**DIVISION OF RATEPAYER ADVOCATES
CALIFORNIA PUBLIC UTILITIES COMMISSION**

**Report on the
Pipeline Safety Enhancement Plan of
Pacific Gas and Electric Company**

Pipeline Modernization Plan

January 31, 2012

1 Figure 13 – Results of PG&E QRA analysis for entire PSEP

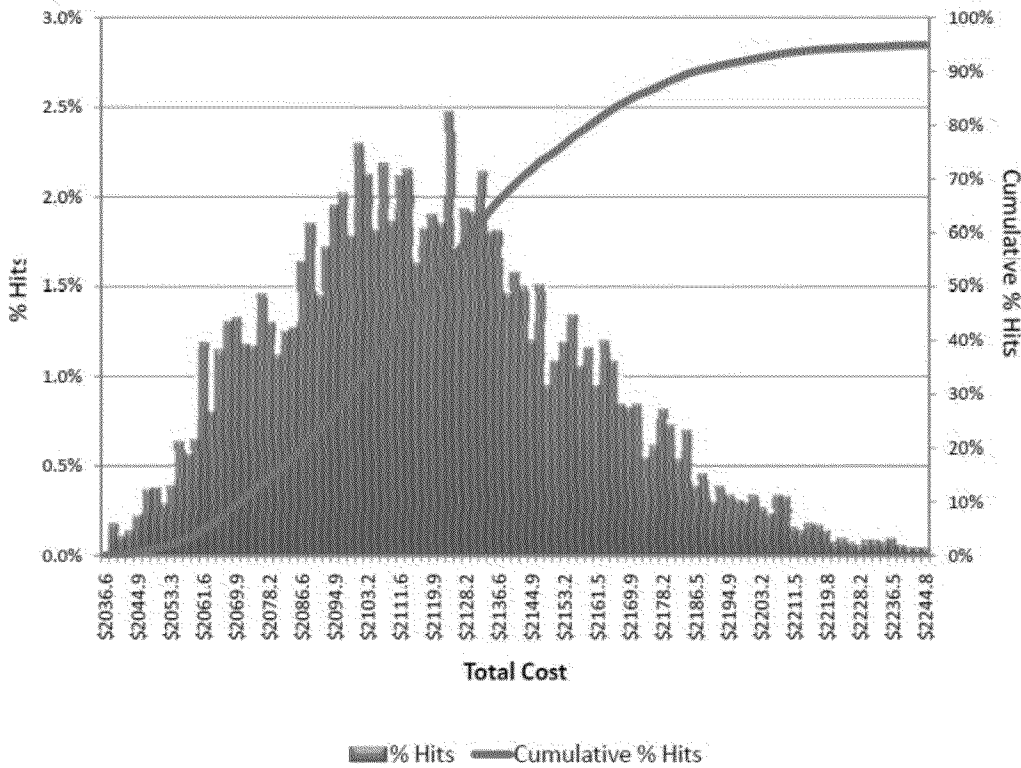
¹⁸⁸ Figure 7-5 in PG&E’s Testimony is incorrect. See PG&E’s response to DRA data request DRA_041-07. A corrected figure was provided in the January 20, 2012 Errata filing, p. 7-42.

1 Figure 7-5 would show that there would be a probability of greater than zero (P0)
2 that actual costs will be less than the 2,036.6 million PG&E shows in Figure 7-5.
3 If PG&E were to use the ACEI Classification Range (-30% to +50%) shown in
4 Table 7-6 for Class 4 estimate, it can be argued that the P0 values should be even
5 *less* than the baseline cost of \$1,803.4 million. Given that DRA's analysis shows
6 PG&E's baseline cost estimate to be higher than industry averages, the QRA
7 should show a significant probability that actual costs could be lower than the
8 baseline estimate. The histogram shown in Figure 7.5 does not show distribution
9 of outcomes for actual costs on either side of the base estimate as the ACEI
10 range for a Class 4 estimate would indicate. At a minimum, the QRA should show
11 a significant probability that actual costs could be less than PG&E's current
12 2,036.6 million estimate at P0. It appears as if PG&E tailored its assumptions for

13 the QRA model to obtain a pre-determined level of contingency for the PSEP
14 Pipeline Plan project, rather than using reasonable assumptions to let the QRA
15 model suggest a proper level of contingency.

- 1 Figure 14 - Results of PG&E QRA analysis for the replacement portion PSEP
- 2 Pipeline Plan pipeline replacement program

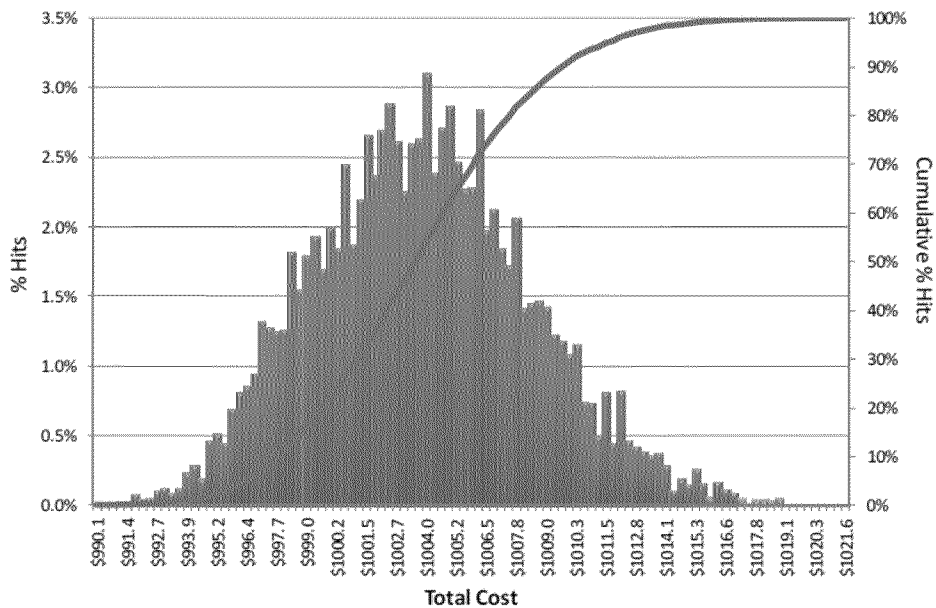
- 3
- 4 This graph makes it look as though there is a wide range of outcomes for actual
- 5 costs. However, recall that the baseline estimate for pipeline capital project,
- 6 primarily pipeline replacement, is \$928.1 million. DRA first reformatted the
- 7 above data to show the Monte Carlo results for pipeline capital projects the 20%
- 8 contingency used by PG&E, and PG&E's P90 value:¹⁹⁰
- 9
- 10

1 Figure 15 – PSEP Contingency request for pipeline replacement compared to
 2 PG&E QRA results¹⁹¹

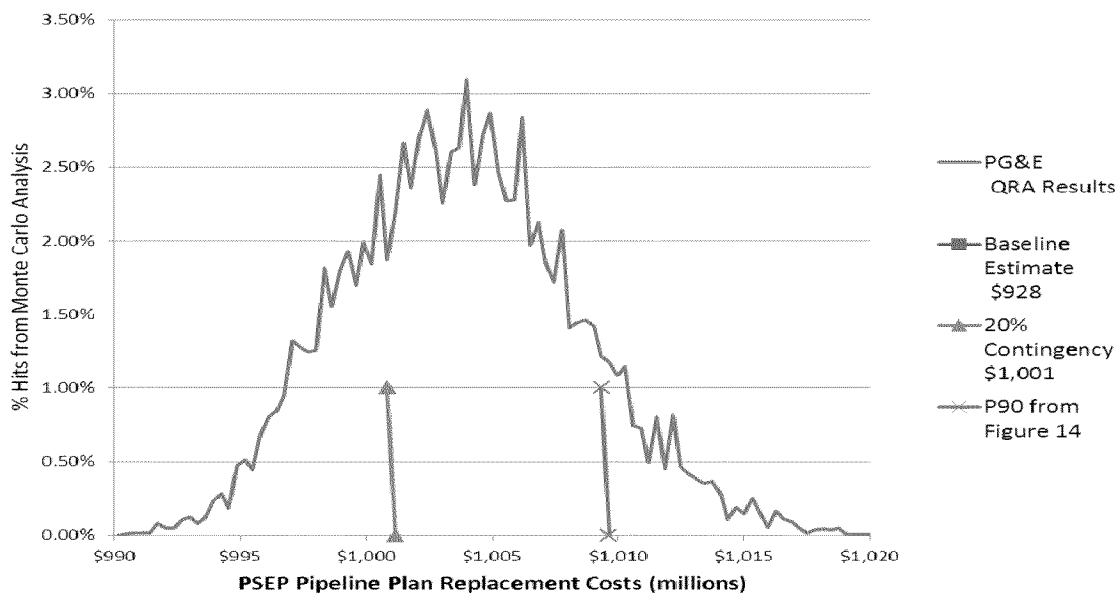
5 Figure 15 illustrates that PG&E’s QRA provides outcomes roughly
 6 centered on the 20% value chosen by PG&E, but skewed to the right (greater
 7 probability of higher cost). This figure also illustrates the discrepancy mentioned
 8 in footnote XXX of this exhibit, since PG&E’s 20% contingency is supposed to be
 9 a P90 value. It is clear from this figure that the 20% contingency is not a P90
 10 value.
